Re: Piedmont Landfill and Recycling Center, Permit No. 34-06
Kernersville, North Carolina

The purpose of this letter is to formally request that gas probe GP-10 be excluded from Waste Management's landfill gas migration compliance network for the Piedmont Landfill. Waste Management will continue to monitor GP-10 according to the same schedule as the other probes and will keep records of the results. These results will be available and provided to NCDENR upon request. Waste Management will not, however, report exceedances of the lower explosive limit (LEL) for methane detections in GP-10. Monitoring of GP-10 would be for informational purpose only, not to demonstrate compliance.

Re: Response to: Facility Compliance Inspection Report
(Inspection date: September 11, 2012)
Piedmont Landfill and Recycling Center, Permit No. 34-06
Kernersville, North Carolina

JOB PIEDMONT LANDFILL
 JOB NO. 392.03 SHEET NO. 1 OF 1
 CALCULATED BY D. MOORE DATE 7-27-00
 CHECKED BY _____ DATE _____
 SUBJECT METHANE @ GP-10 SCALE NTS

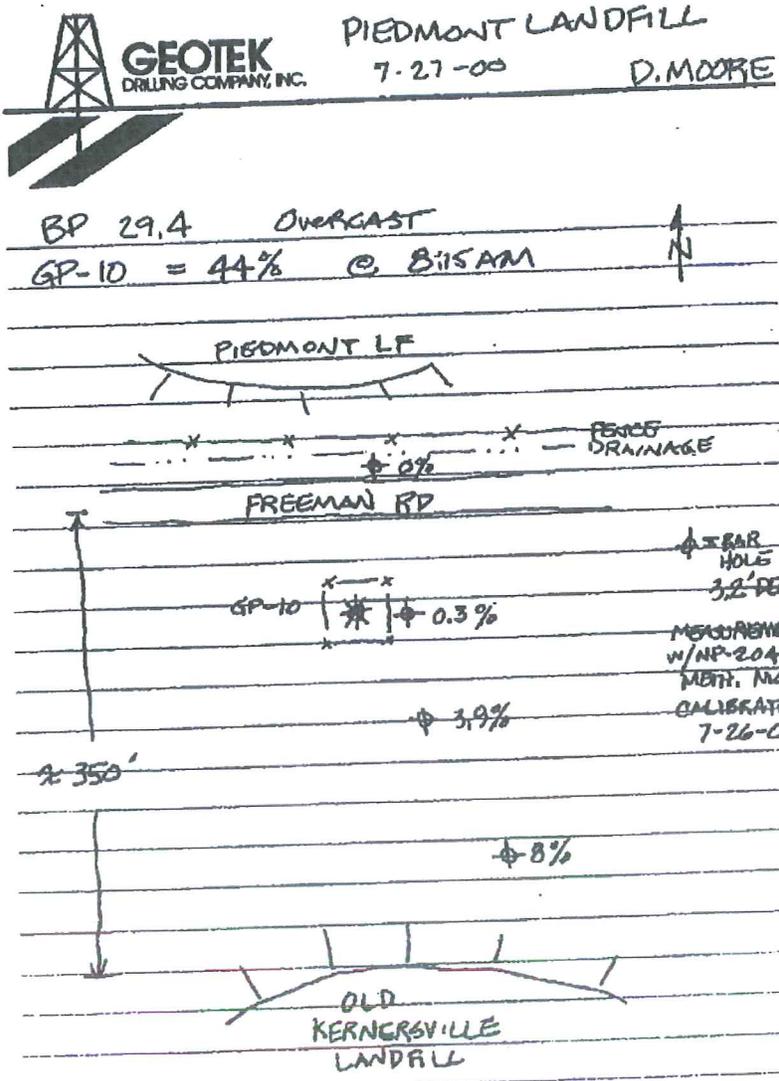
- This letter referenced a barhole probe study that was completed on July 27, 2000. The study was conducted to determine if the Piedmont Landfill was or was not the source of the methane exceedances recorded at GP-10. Mr. Snyder proposed that GP-10 be exempt from future notification of LEL exceedances due to the conditions documented within the study.

- Our records do not include a copy of the study referenced in Mr. Snyder's 2005 letter and the information submitted in the letter did not provide sufficient information to allow for a determination as to the cause of elevated methane levels above the LEL at GP-10. In addition, please submit a copy of the 2000 study referenced in Mr. Snyder's letter and/or any additional information you may have on the elevated methane levels at GP-10.

A copy of the July 27, 2000 gas migration study near GP-10 is attached as Attachment B. The July 2000 gas migration study shows that as sample locations approach the old Town of Kernersville Landfill from GP-10 the measured methane concentrations increased, and as sample locations approach the Piedmont Landfill from GP-10 the measured methane concentrations decreased. The trend in the methane readings in the July 2000 methane migration study shows that the methane source is the Kernersville Landfill and not the Piedmont Landfill.

NOTE
 THIS INFORMATION DEMONSTRATES THAT THE HIGH CONCENTRATIONS OF METHANE DETECTED @ GP-10 ARE THE RESULT OF SUBSURFACE MIGRATION COMING FROM THE CLOSED KERNERSVILLE LANDFILL.

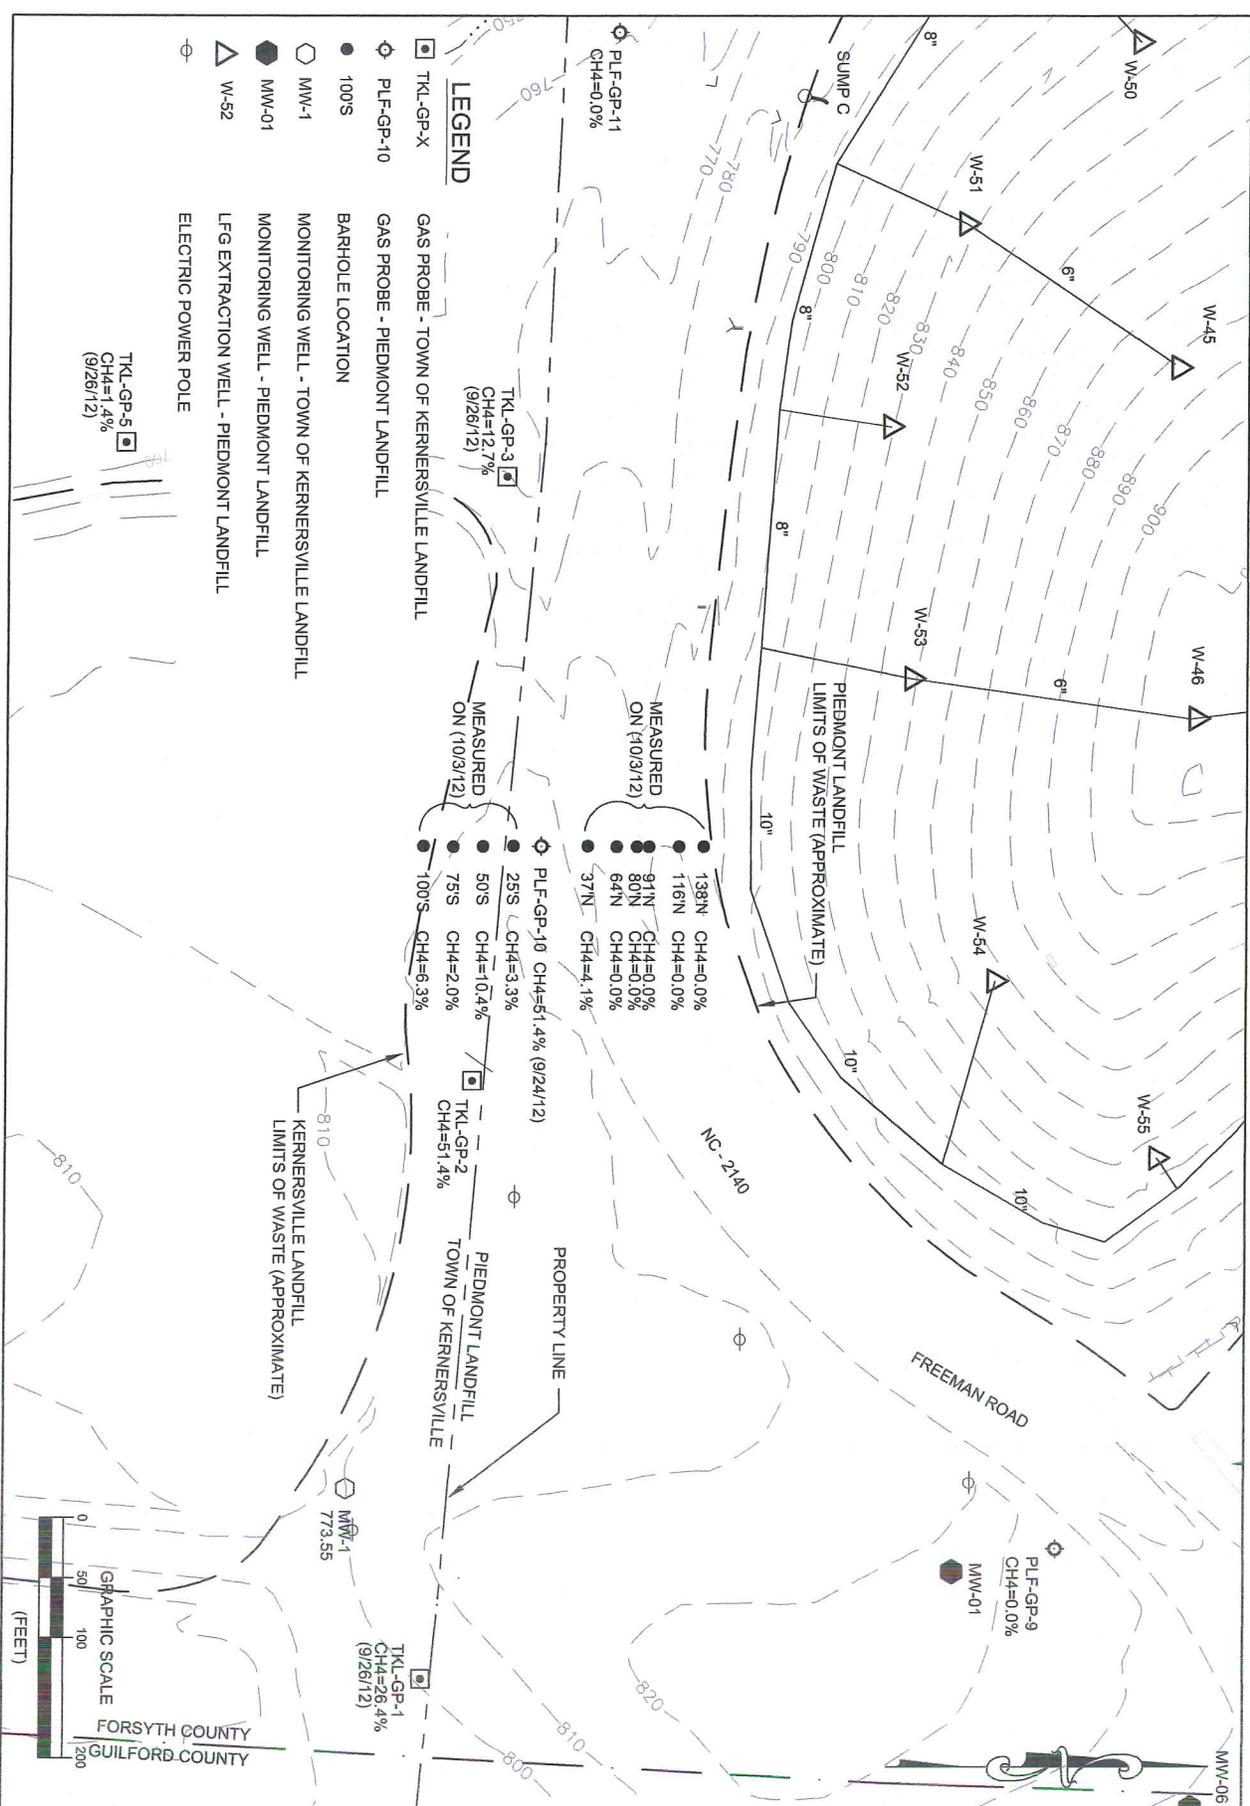
- Therefore, within 10 days of receipt of this report, please contact Jaclynne Drummond, Compliance Hydrogeologist at (919) 707-8294 to discuss the elevated methane levels at GP-10. Additional assessment will be required to further investigate methane migration within the area near GP-10. Corrective actions may also be required to address the elevated methane issue near GP-10. Information may be forwarded via email to jaclynne.drummond@ncdenr.gov or via US Mail to: 1646 Mail Service Center, Raleigh NC 27699-1646.

We recently completed a methane migration investigation near GP-10. Attached as Attachment C is an updated historical summary table of boundary probe readings from the years 2000 through 2012; a table showing the results of additional onsite bar-hole probe investigations that were completed in September and October of 2012; and a landfill gas delineation map. The delineation map shows that gas probes for the Kernersville Landfill have had high concentrations of methane detected, and that the City's GP-2, which is closest to Piedmont's GP-10 has the highest methane concentration. From Piedmont's GP-10, the methane concentration increases as we approach the Kernersville Landfill, and methane concentration drops to zero beyond 37 feet from GP-10 and remains zero towards Piedmont Landfill. The recent September/October 2012 gas migration investigation provides very strong evidence to support the idea that the source of the methane in GP-10 is not the Piedmont Landfill, but rather the Kernersville Landfill. Please also keep in mind of the following facts:

- The highest methane concentration (51.4%) on the Kernersville Landfill property is in the probe nearest GP-10.
- Bar-hole probe measurements made in July 2000 and in September and October 2012 show more detections of methane in the near-surface between GP-10 and the Kernersville Landfill than between GP-10 and the Piedmont Landfill (see attached map and table).

We believe that the information submitted in this letter is sufficient to allow for a determination that the Piedmont Landfill is not the source of methane in GP-10. As we have requested previously in the March 25, 2005 letter to NCDENR, we again request that GP-10 be exempt from future notifications of LEL exceedances due to the facts and conditions presented. We are forwarding a copy of this letter and attachments to Jackie Drummond and we will call her in the next few days to discuss this issue.
